RIGHT OF WAY FILE No. 7851

APPLICATION FOR RIGHT OF WAY
D E CO FORM MS 80

By..... **NEW CONSTRUCTION BY PUBLIC UTILITIES OPERATING**
in the
CITY OF PONTIAC, MICHIGAN

PROPOSED CONDUIT AND MANHOLE IN
N.W. Woodward, South Blvd. to Alley, South

U-378-593

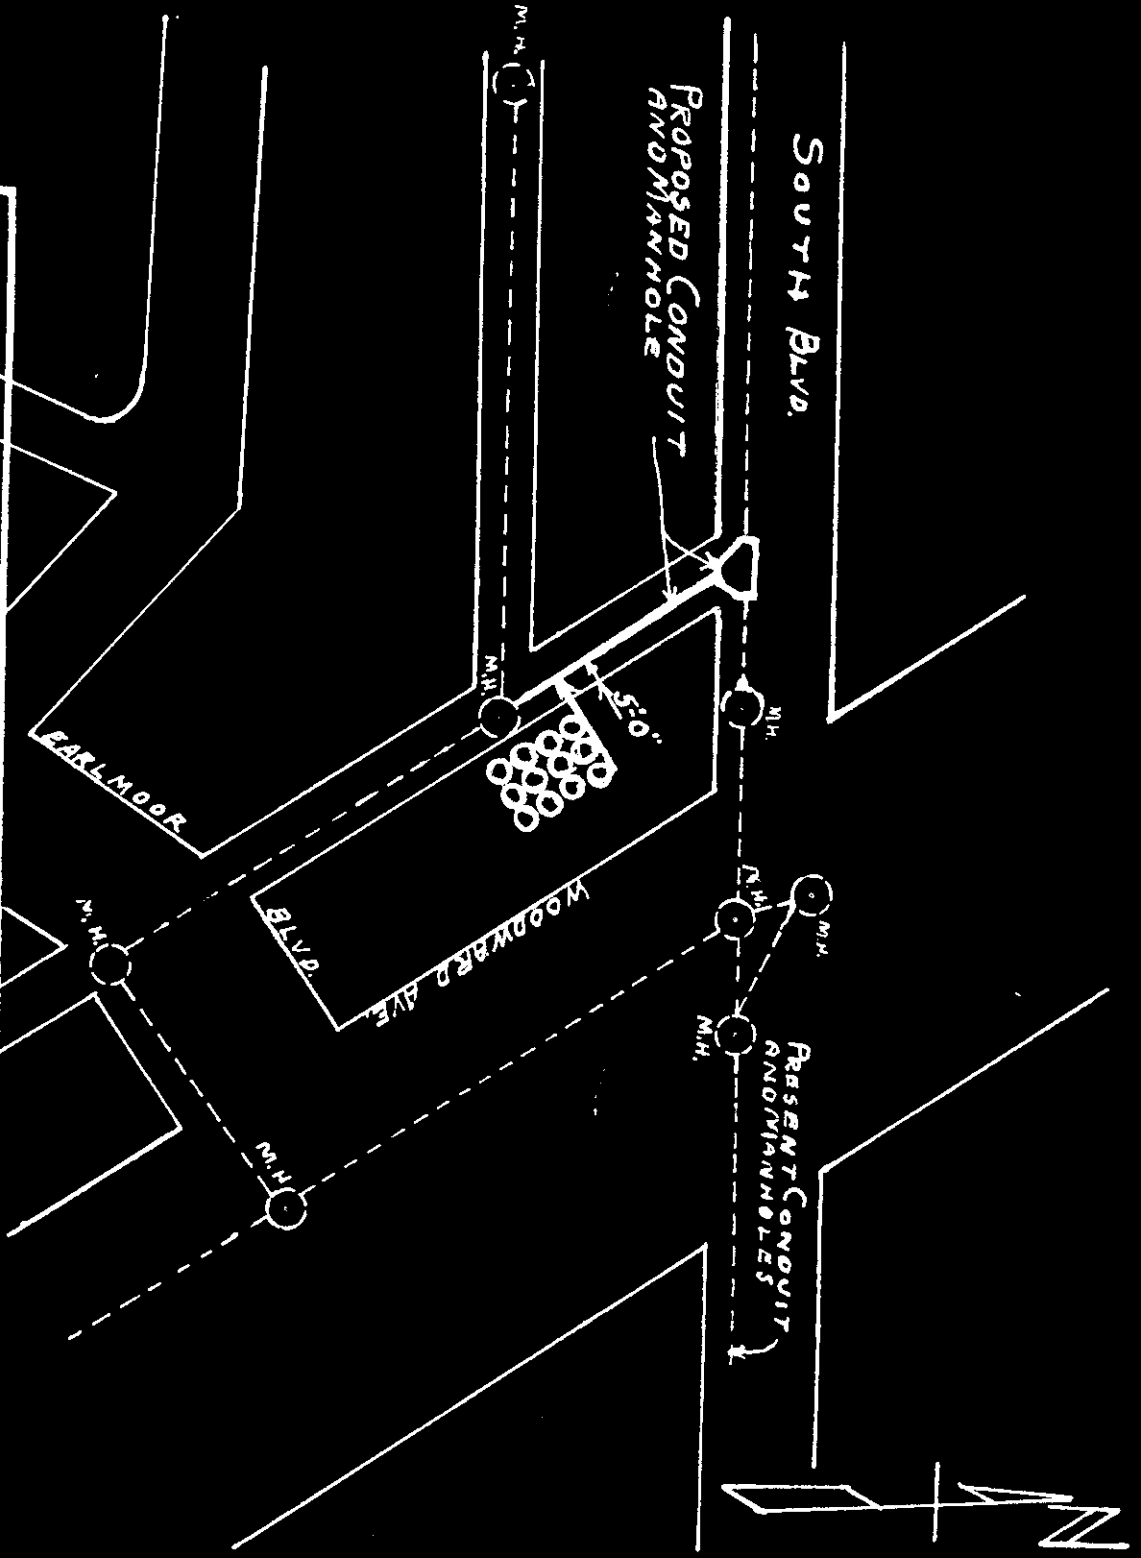
*Note: Proposed 16" Water Main to be constructed between duct
line on E. side of E. property line of E. Blvd. Max. depth
of bottom of ducts not to
exceed 57"*
